UNITED STATES PATENT AND TRADEMARK OFFICE

APPLICATION NO.	FILING DATE	FIRST NAMED INVENTOR	ATTORNEY DOCKET NO.	CONFIRMATION NO.
10/774,703	02/02/2004	George Vodin	10808-1	7372

Office Action Summary	Application No.	Applicant(s)	
	10/774,703	VODIN, GEORGE	
	Examiner	Art Unit	
	Jared W. Newton	3634

DETAILED ACTION

Fig. 1

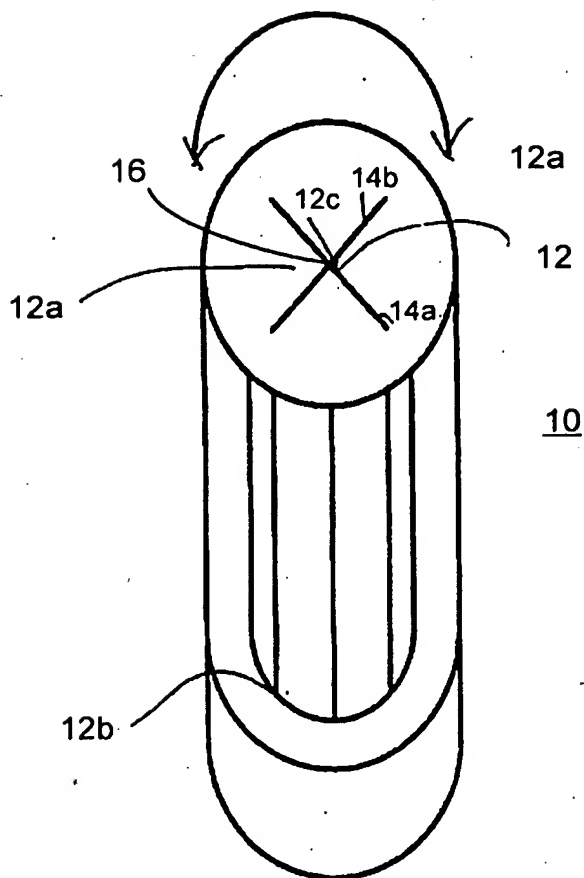
The drawings were received on January 9, 2006. These drawings are acceptable in part. In particular, the inclusion of the noted missing reference characters and correction of the noted illegible reference characters is accepted. New corrected drawings in compliance with 37 CFR 1.121(d) are required in this application because Figures 2c and 2d contain broken and unclear lines not in compliance with 37 CFR 1.84 (I). Applicant is advised to employ the services of a competent patent draftsman outside the Office, as the U.S. Patent and Trademark Office no longer prepares new drawings. The corrected drawings are required in reply to the Office action to avoid

The drawings are objected to under 37 CFR 1.83(a). The drawings must show every feature of the invention specified in the claims. Therefore, the hook-and-loop fasteners of claims 2, 12, and 16 must be shown or the feature(s) canceled from the claim(s). No new matter should be entered.

Drawings
Approved in part
JUN 03/07/2006

Corrected drawing sheets in compliance with 37 CFR 1.121(d) are required in reply to the Office action to avoid abandonment of the application. Any amended replacement drawing sheet should include all of the figures appearing on the immediate prior version of the sheet, even if only one figure is being amended. The figure or figure number of an amended drawing should not be labeled as "amended." If a drawing figure is to be canceled, the appropriate figure must be removed from the replacement sheet, and where necessary, the remaining figures must be renumbered and appropriate changes made to the brief description of the several views of the drawings for consistency. Additional replacement sheets may be necessary to show the renumbering of the remaining figures. Each drawing sheet submitted after the filing date of an application must be labeled in the top margin as either "Replacement Sheet" or "New Sheet" pursuant to 37 CFR 1.121(d). If the changes are not accepted by the examiner, the applicant will be notified and informed of any required corrective action in the next Office action. The objection to the drawings will not be held in abeyance.
